MINUTES
**BOARD OF BUILDING STANDARDS/
ARCHITECTURAL BOARD OF REVIEW/SIGN REVIEW**
REVIEW MEETING
CITY OF LAKEWOOD
12650 DETROIT AVENUE
AUDITORIUM
NOVEMBER 9, 2023
5:30 P.M.
RECORDED
<https://www.lakewoodoh.gov/videos-2/>

Architectural Board of Review

November 2023

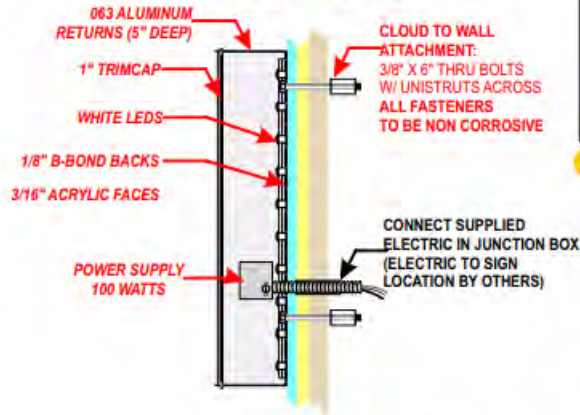
SURVEY NEEDED TO VERIFY DIMENSIONS

NEED SIGN PLACEMENT APPROVAL

- **The sign panel background to remain the matching color that exists on the rest to the front of the building.**

PROPOSED SITE PLAN

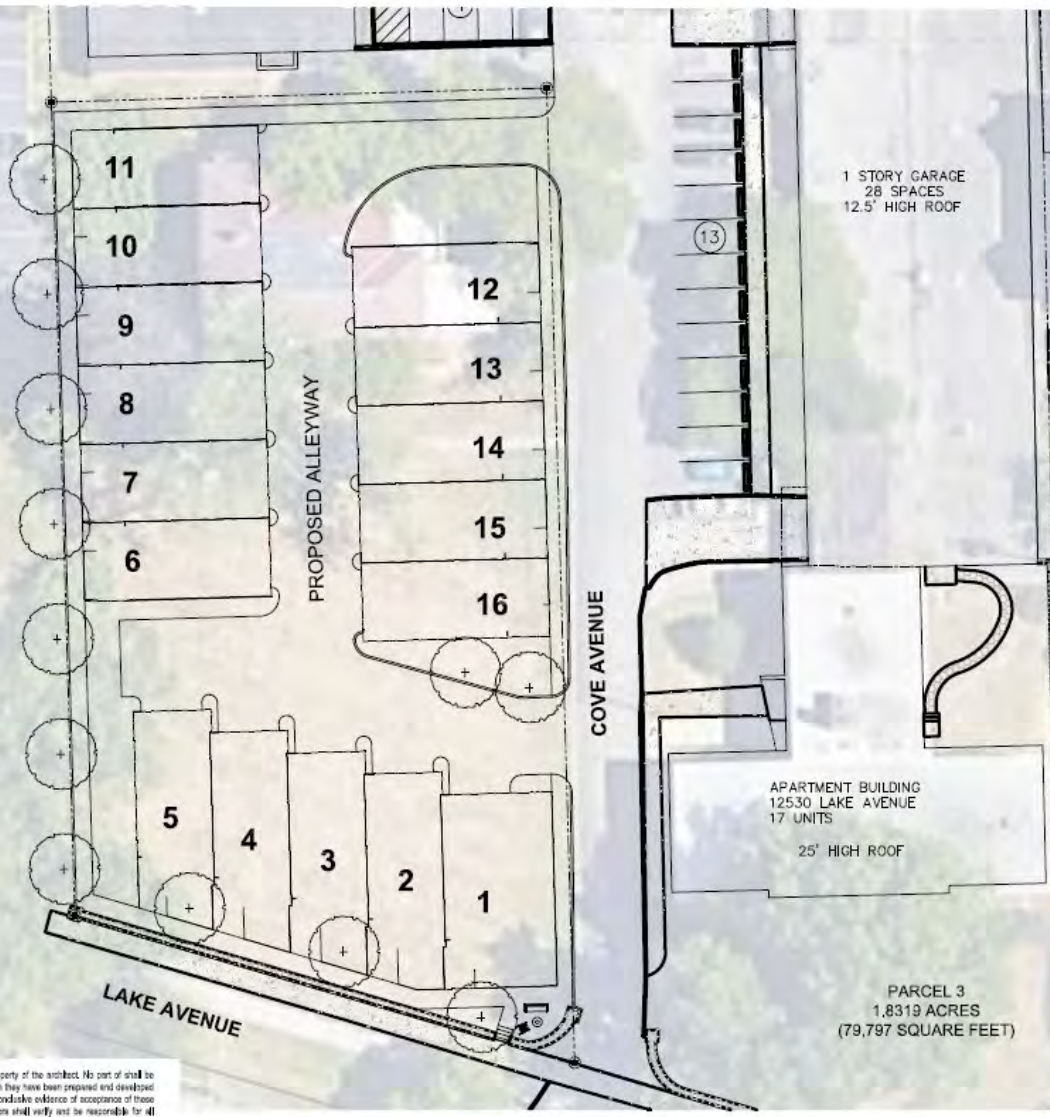
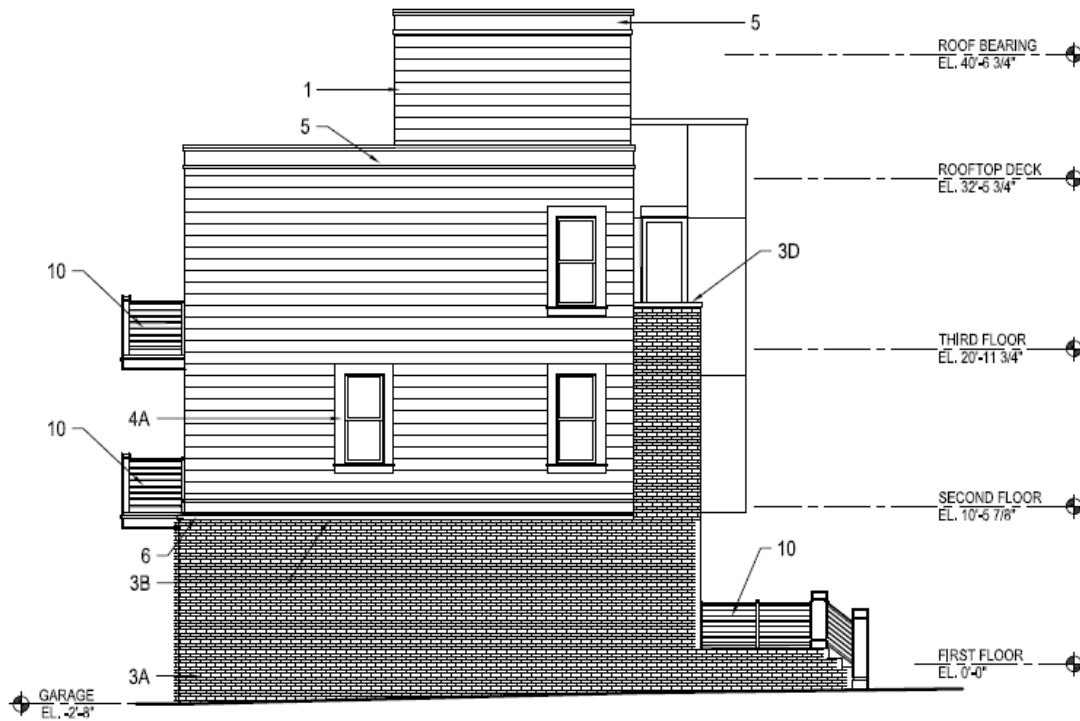
- Can the City/RTA work with this property owner to add a paved sidewalk/waiting area from the sidewalk to the bus stop loading zone?
- Question the choice of trees as landscaping on the west side (townhouses 6-10.) Would they be viable?

- What was Planning Commissions thoughts on this plan? Particularly emergency access to Townhouses 6-10?
- Is an enclosed dumpster on the north side the correct choice for these? Can trucks navigate the neighboring curb cut/turning radius to service that? It seems small as well

- Suggest looking at ways to incorporate more landscaping features. Especially between units 11-16 and the curb.
 - Suggest studying a way to provide a sidewalk connection to Lake Ave due to the existing low stone wall to remain.

- Two bus stops exist already.
- 6. What were the Planning Commission's thoughts on this plan? Particularly emergency access to Townhouses 6-10?
 - This will be Planning Commission's purview.

- No, refuse receptacles will be in the individual residence garages. Refuse trucks will be able to navigate.
- 8. Suggest figuring out a way to provide a least one townhouse with on-trade entry at the front and garage – no steps. (Question whether it's actually on-grade entry at the garage if it's a couple feet up at the front?)

FRONT ELEVATION: TOWNHOUSES 1 - 5

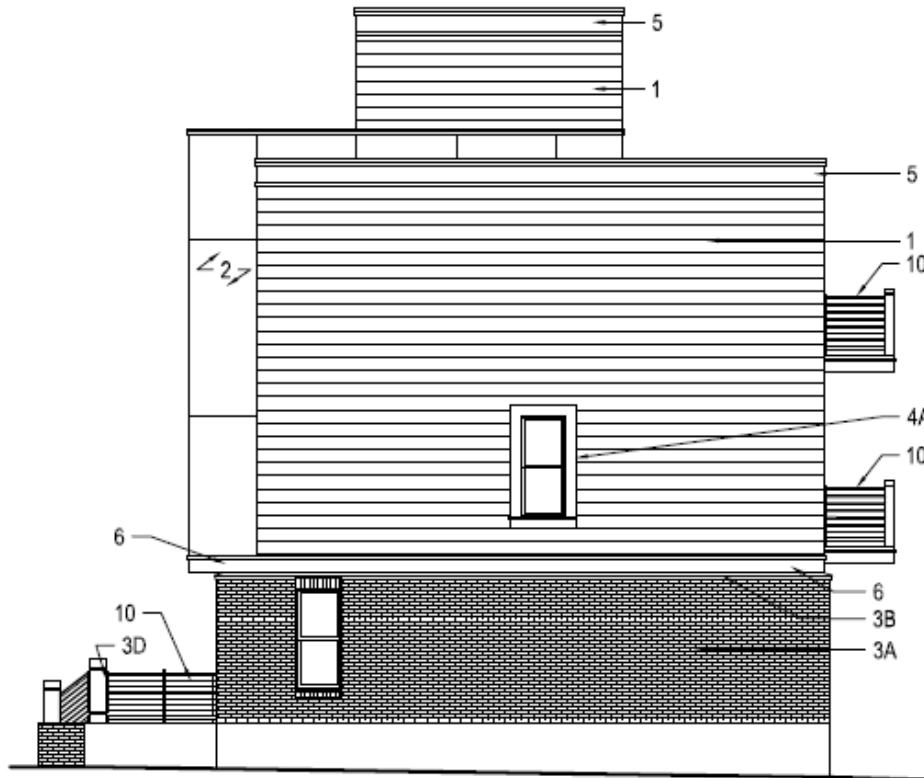
- 14. Will there be HVAC equipment located on the roof? If so, what type?
 - Yes, behind the parapet or in the garage.
- 15. Plans and elevations don't match in certain instances.

- For example, in townhomes 1-5, the ground floor den shows an exterior door in plan. and the doors are not shown in elevation.
 - Still in discussions.

- Will there be HVAC equipment located on the roof? If so what type?
- Plans and elevations don't match in certain instances.
 - For example, in Town Homes 1-5, the ground floor den shows an exterior door in plan and however the doors are not shown in elevation.
